2001 MODEL YEAR CHANGES

Model: E39 (525i/iT, 530i, 540i/iT, M5)

20 PIN DIAGNOSTIC SOCKET DELETION

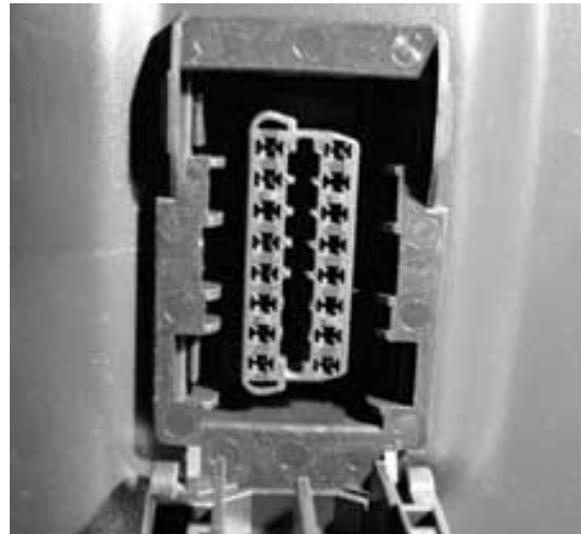
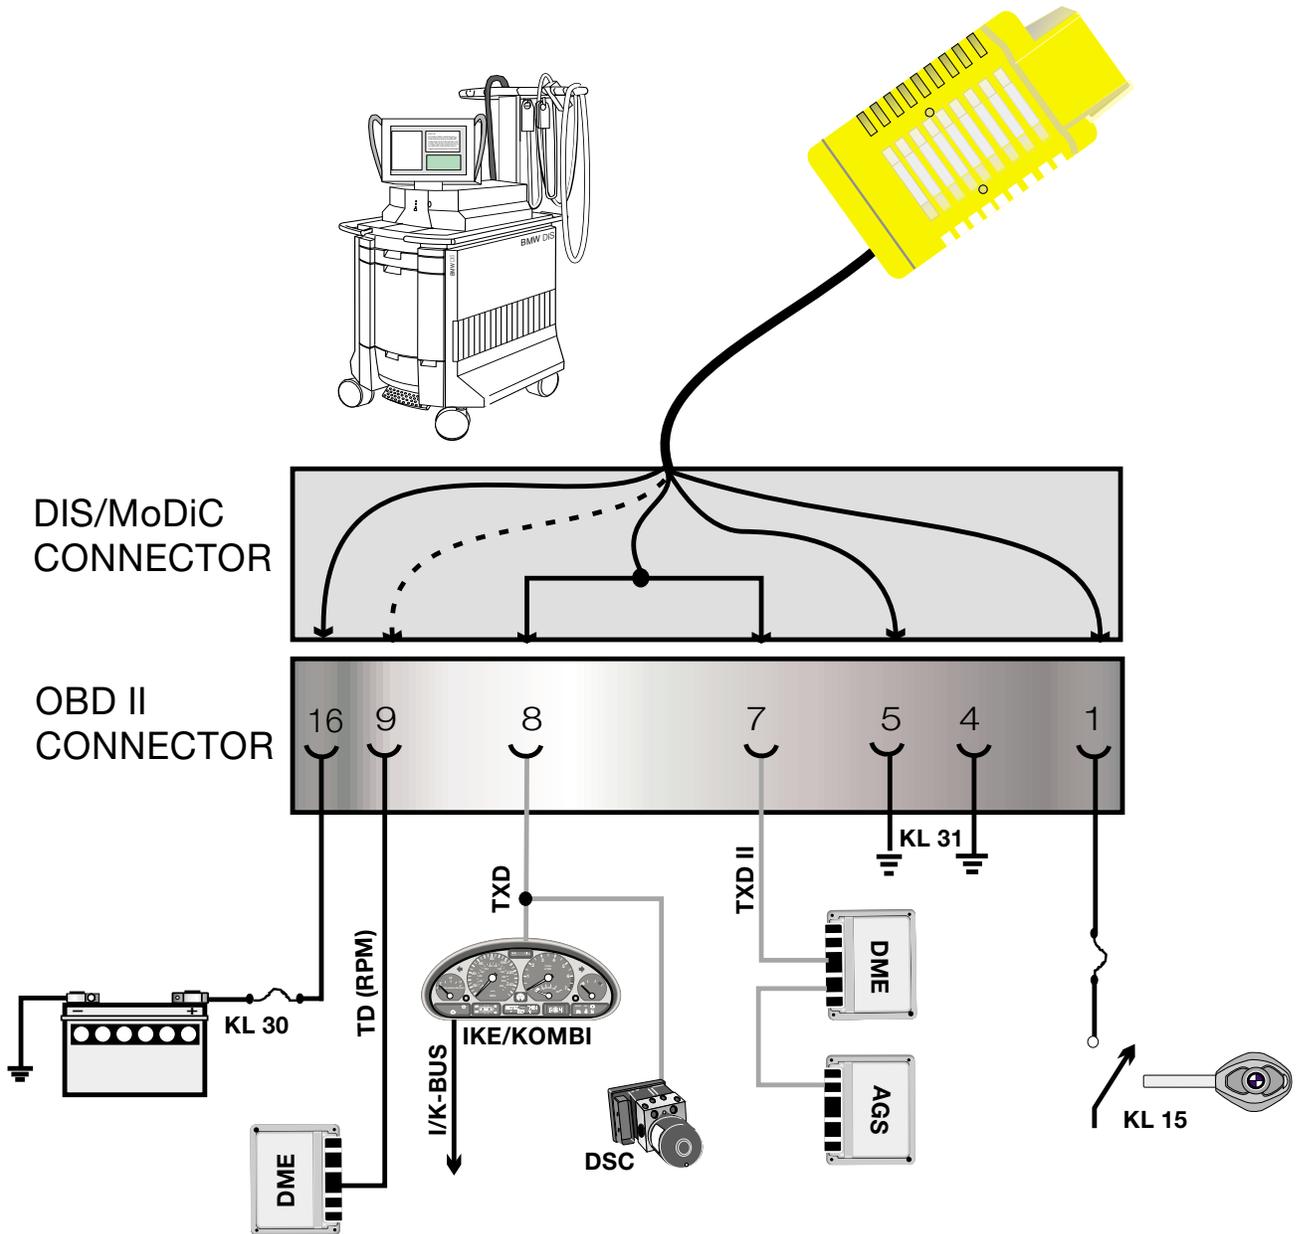
For model year 2001 the E39, E46 and E53 will eliminate the 20 pin diagnostic connector from the engine compartment. The 16 pin OBD II connector located inside the vehicle will be the only diagnosis port.

Previously before 2001, only emissions relevant data could be extracted from the OBD II connector because it did not provide access to TXD (D-bus). The TXD line is connected to pin 8 of the OBD II connector on vehicles without the 20 pin diagnostic connector.

The cap to the OBD II connector contains a bridge that links KL 30 to TXD and TXD II. This is to protect the diagnostic circuit integrity and prevent erroneous faults.

INSTRUMENT CLUSTER SIA RESET

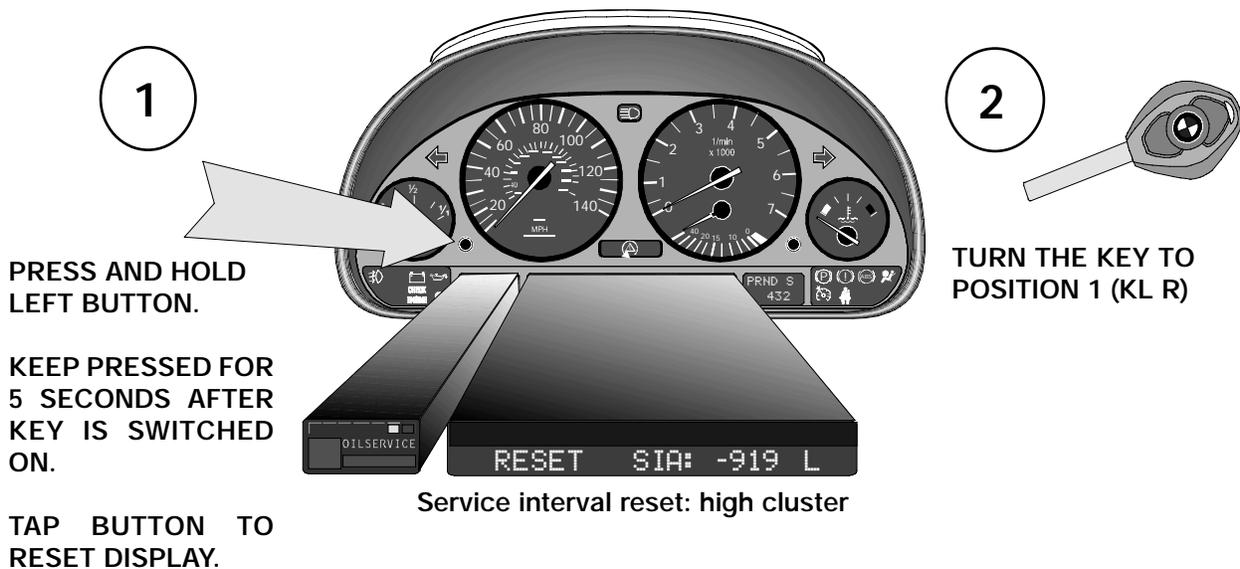
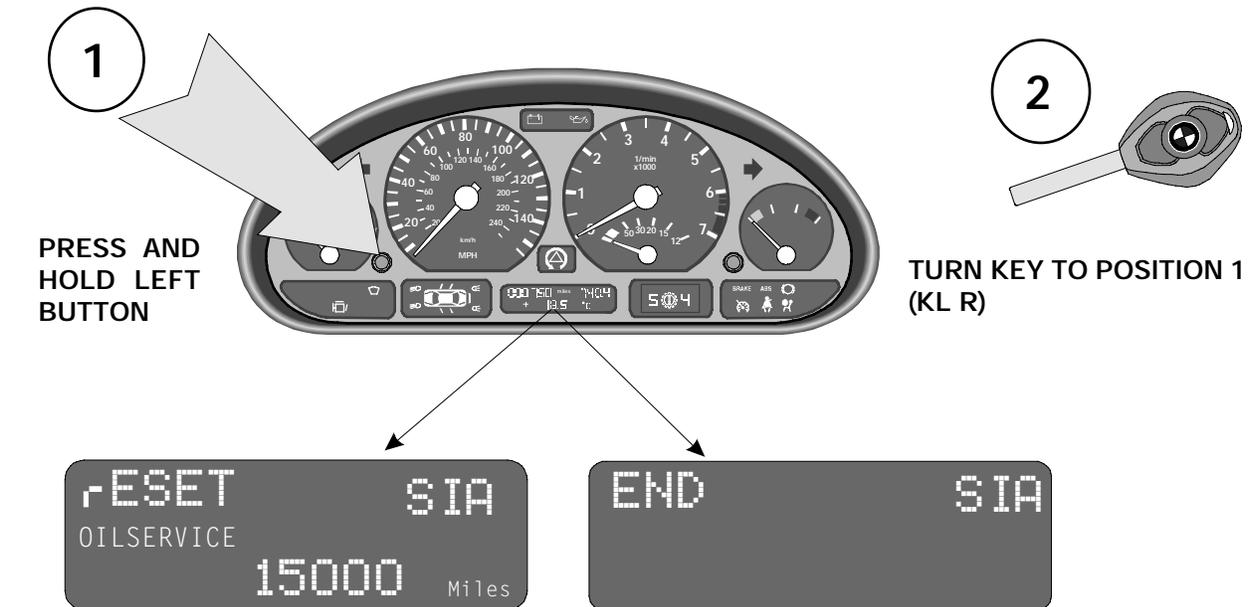
On 2001 vehicles without the diagnostic connector in the engine compartment, the use of the SIA reset tool is not possible. The service indicator may be reset using the reset mode in the instrument cluster.

Head and Tail Lights

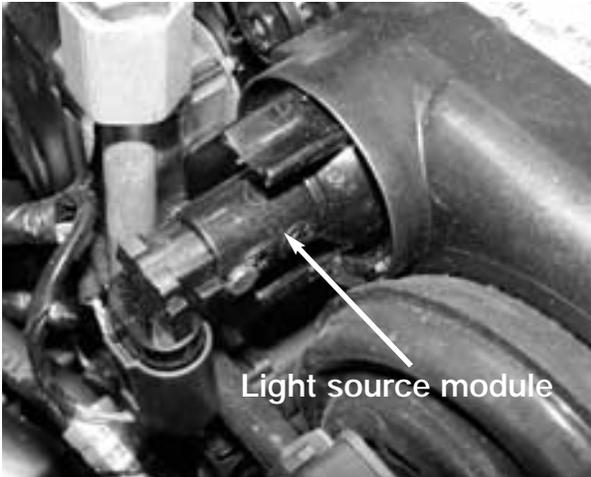
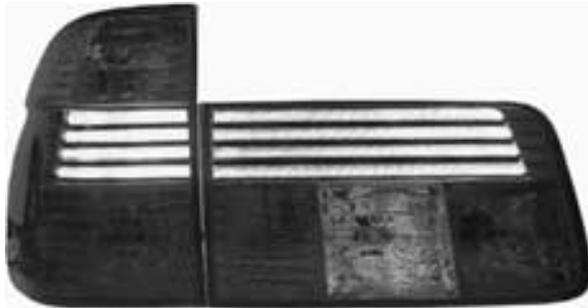
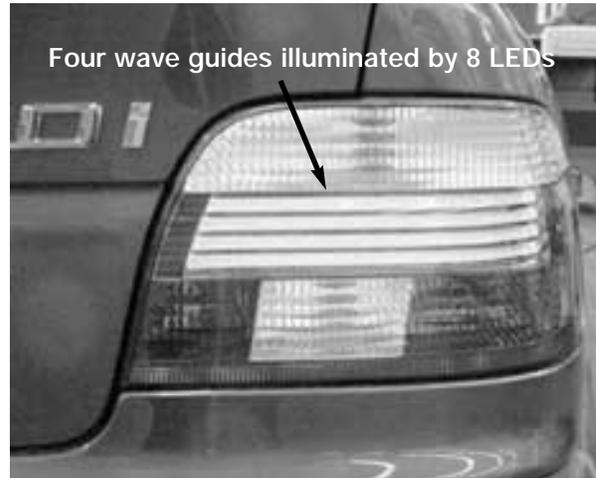
The head and tail lights of the 2001 E39 have received a new look, utilizing optical wave guide technology. The wave guides are an innovation that are not only aesthetically pleasing, but also enhance safety.

The front headlights have been completely redesigned, however they fit into the existing body without any sheet metal changes. The high and low beam headlights are free-form reflectors and no longer use the glass lenses. The turn signal has been given its own circular lens next to the low beam.

The parking light and side marker use the optical wave guide technology. Clear rings surround the high and low beam reflectors. The rings are illuminated by a light source module similar to the ones used in the Visual Entry Aid system. Output voltage for the light source module comes from the parking lamp final stage of the LCM III. There is one light source module located at the back of the head light housing between the high and low beam headlights. The side marker for US models also has an additional wave guide conductor for illumination.

Sedan left tail light housing

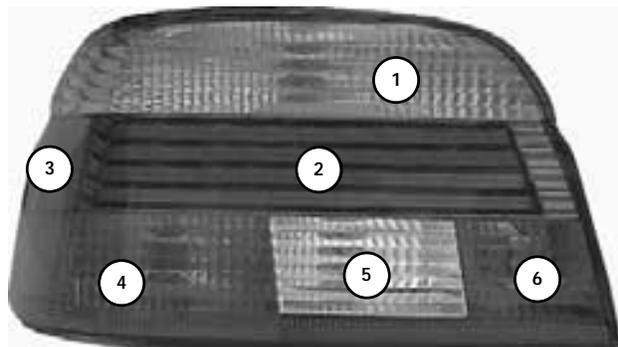
Each tail light housing contains 4 wave guide assemblies. At either end of the wave guides is a printed circuit board with 4 LEDs. The LEDs provide the illumination for the tail light only. US models use an additional 4 LEDs in the corner of the housing as a side marker.

The function of the LCM III remains unchanged from the previous year with the exception that because of the LED illuminated tail lights, there is no tail light monitoring function. The LCM III module has been updated for the new lighting features of the 2001 E39. All replacement LCM modules will supercede to this version in the parts system and it can be used on earlier vehicles.

E39 IHKA IV I.P.O.

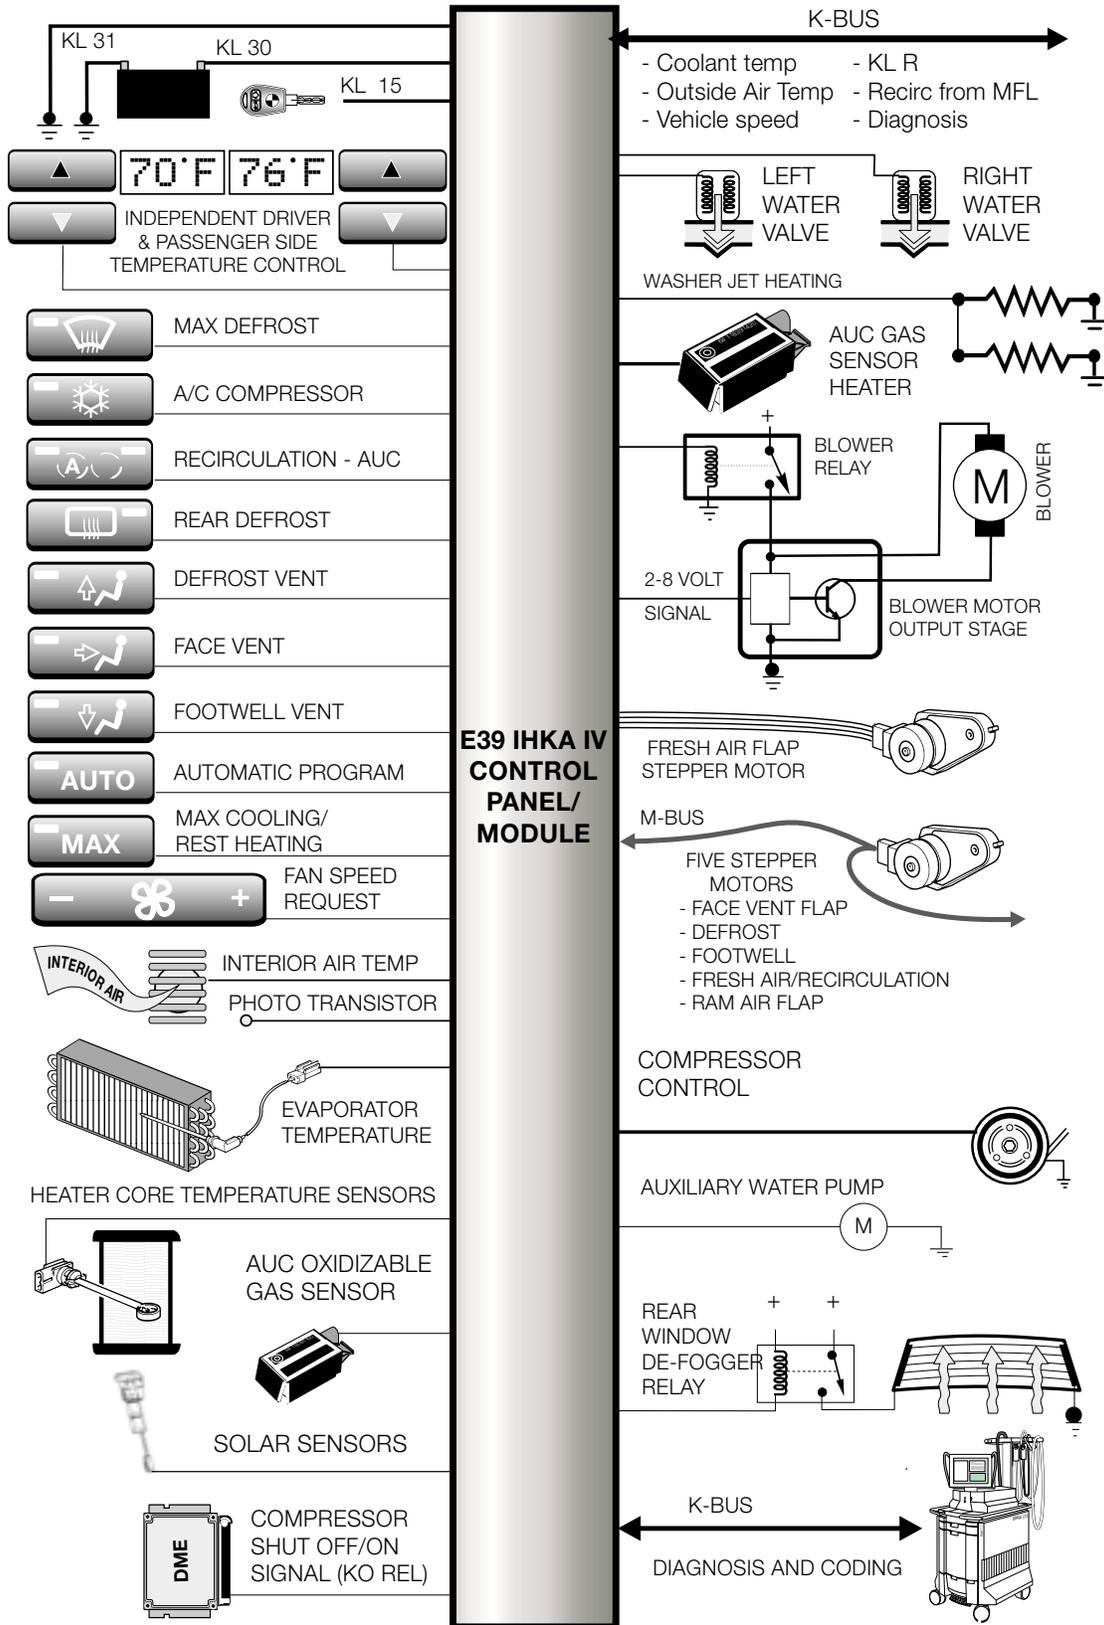
- New Control Unit (since 9/00).
- Addition of solar sensor (since 9/00).
- New IHKA integrated heater and air conditioning case (since 3/00).

Solar Sensor

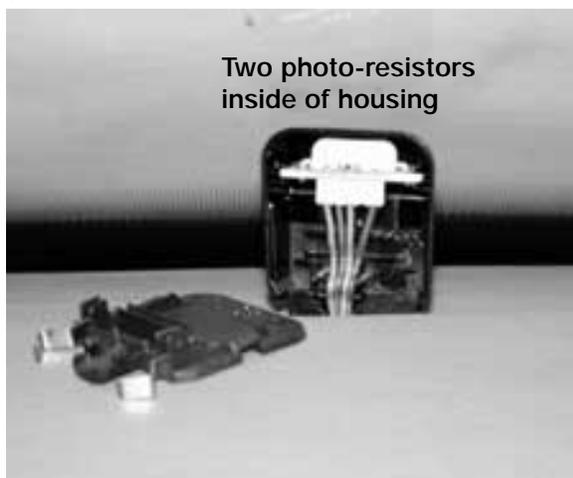
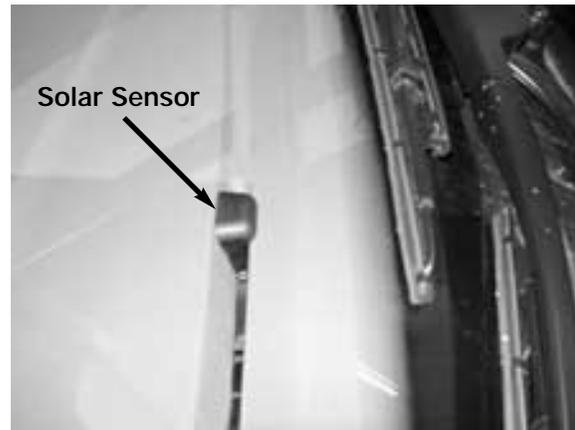
The IHKA IV integrates the solar sensor into the calculation used to automatically regulate the interior vehicle temperature. The sensor is located in the right side defrost outlet.

IHKA integrated heater and air conditioning case

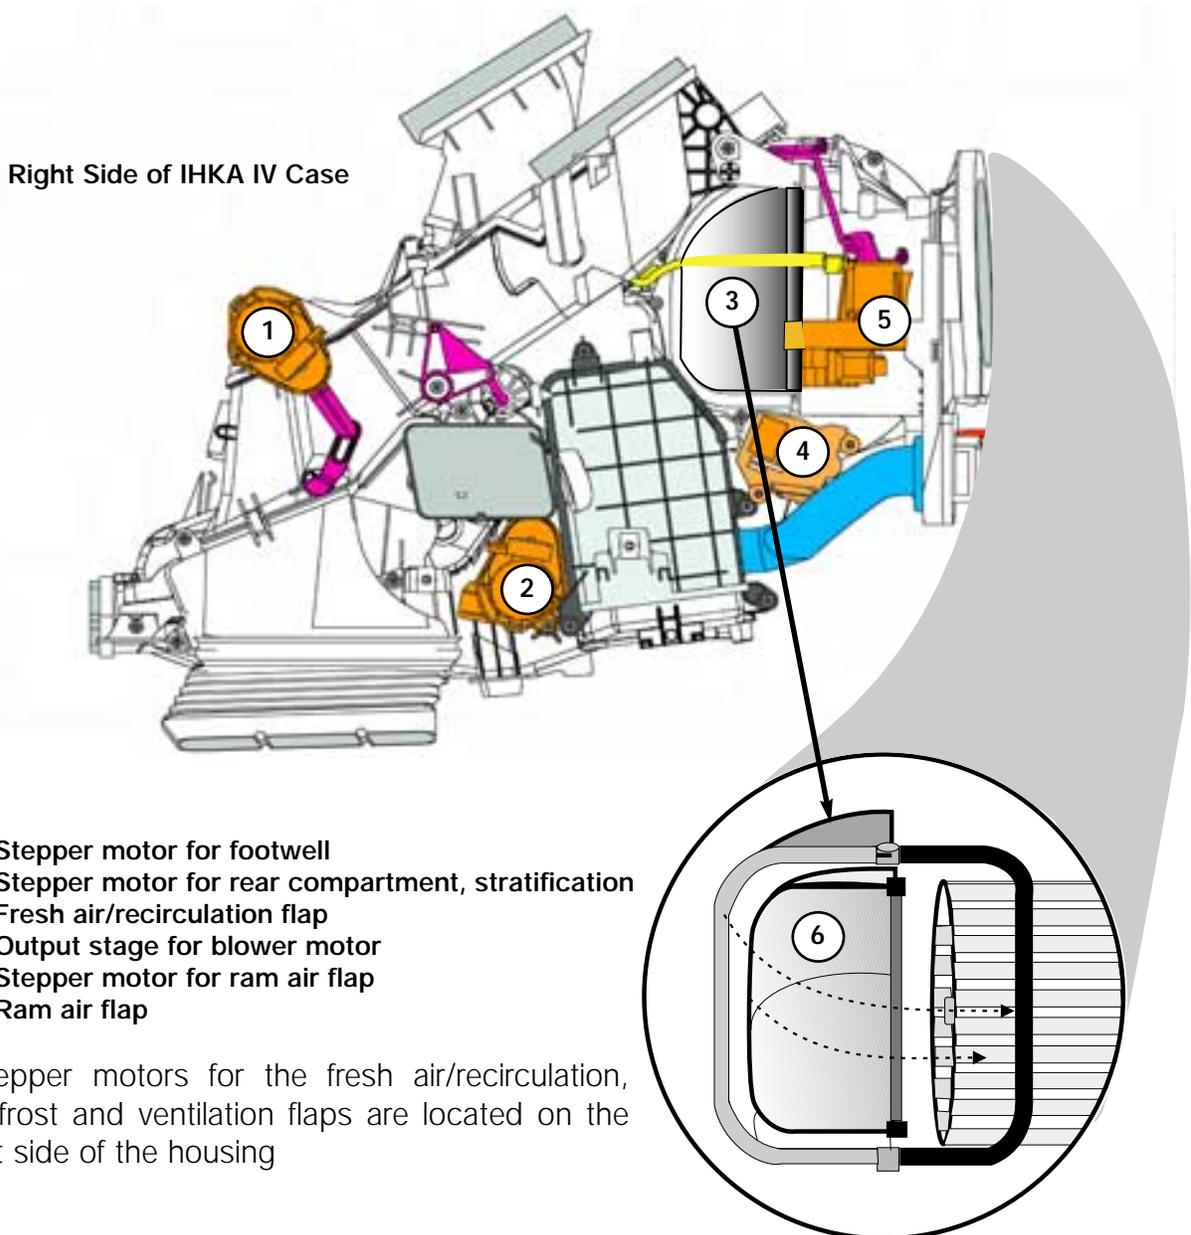
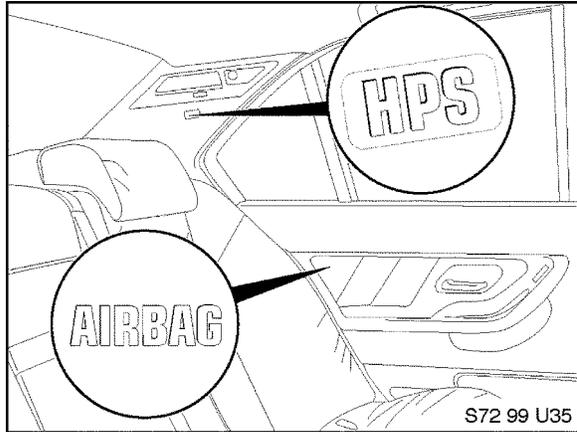
The E39 IHKA case has been redesigned since 3/00. The E39 and E53 both share the same case design.

The difference from the previous case is that a single flap (left and right), controls both the fresh air and recirculation inlets. Ram air is controlled by a separate flap. What makes it possible to use a single flap for fresh air/re-circ is the semi-circular door; as one inlet is covered another is opened.
